ORIGINATION FORM

Proposed Revisions to a Standard Plans Index

Index Number: 715-001

Index Title: Conventional Lighting

METAL POLE WIRING DETAIL

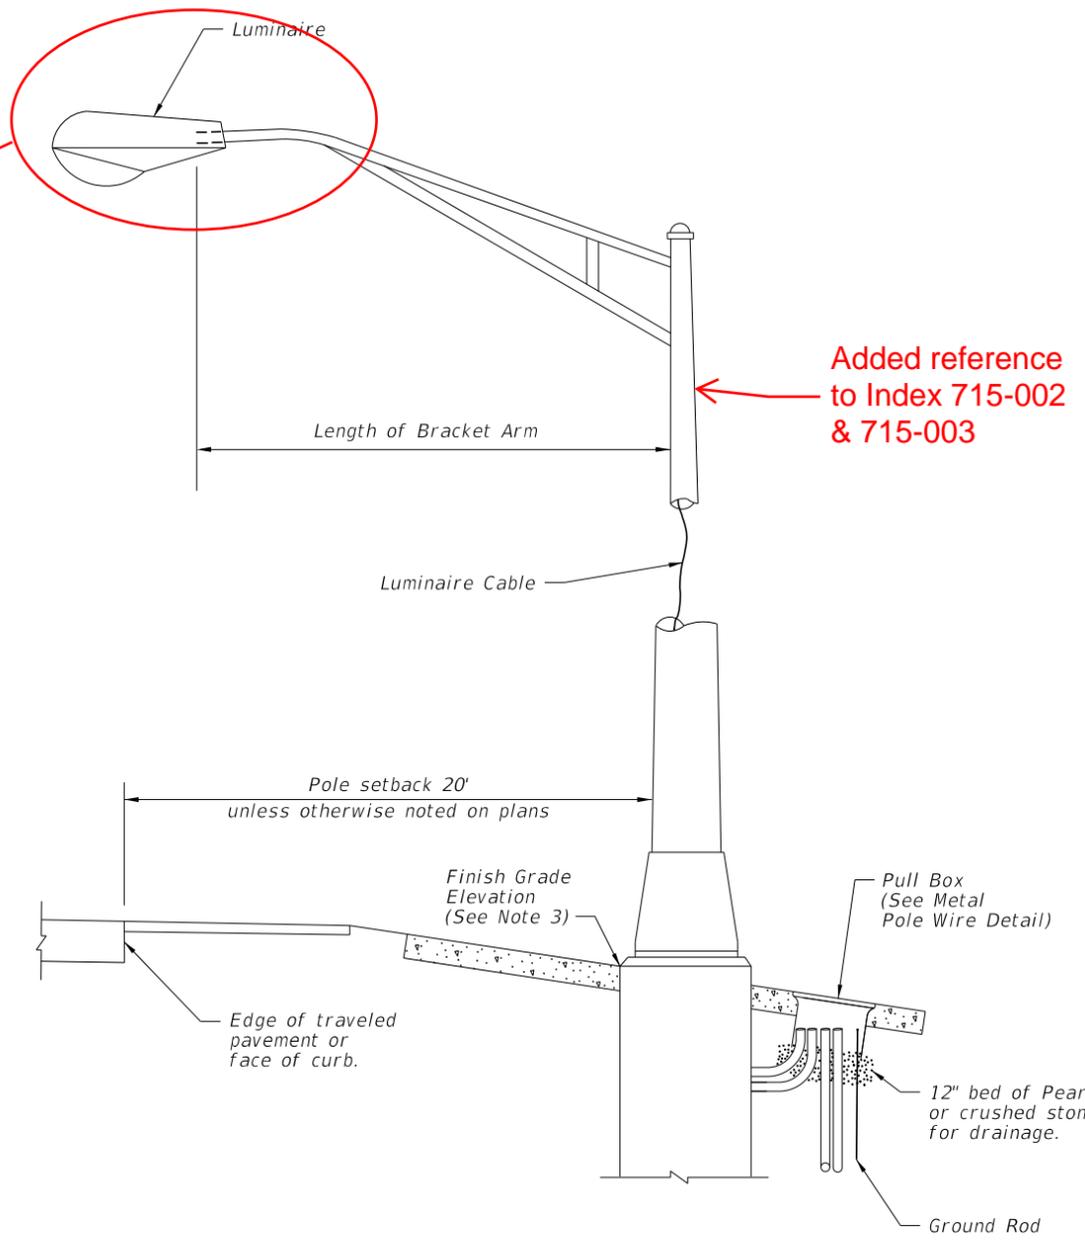
Added "Luminaire Tilt Detail"

Added reference to Index 715-002 & 715-003

LUMINAIRE TILT DETAIL (Side View)

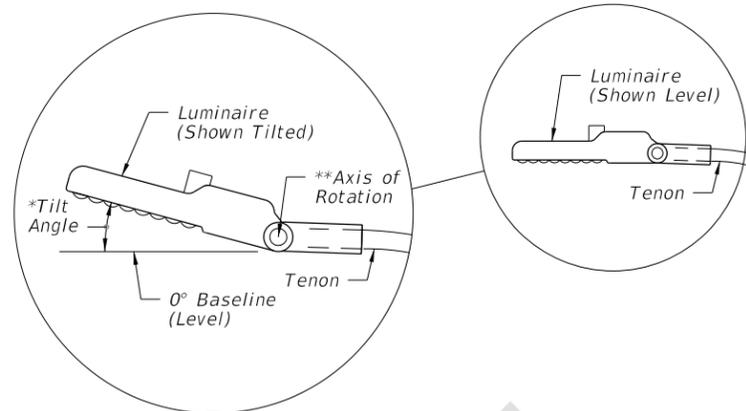
Sheet 1: Added a detail to define luminaire tilt angle for designers and contractors; Added reference to Index 715-002 and 715-003 to the Metal Pole Detail; Changed sheet title to "Wiring and Installation Details" to capture the installation details beyond wiring.

The Turnpike Design Handbook (TDH) had previously required designers to include a project-specific plans detail to explain the luminaire "tilt". As part of the TDH migration, a detail to define tilt angle is being placed into this Index in order to meet this need without requiring a project-specific plans detail. Luminaire tilt angle is a common term for lighting designers using ANSI/IES RP-8-18 national guidance and AGI32 lighting design software, but tilt angle was previously not defined for contractors. Last, this "tilt" variable is being added to the standard Lighting Table per FDM 943.

*Tilt angle is 0° (level) unless otherwise shown in the Plans
 **Axis of rotation is level and perpendicular to the tenon.
 The location shown is approximate and may be either a hinge or a tenon connection adjustment.
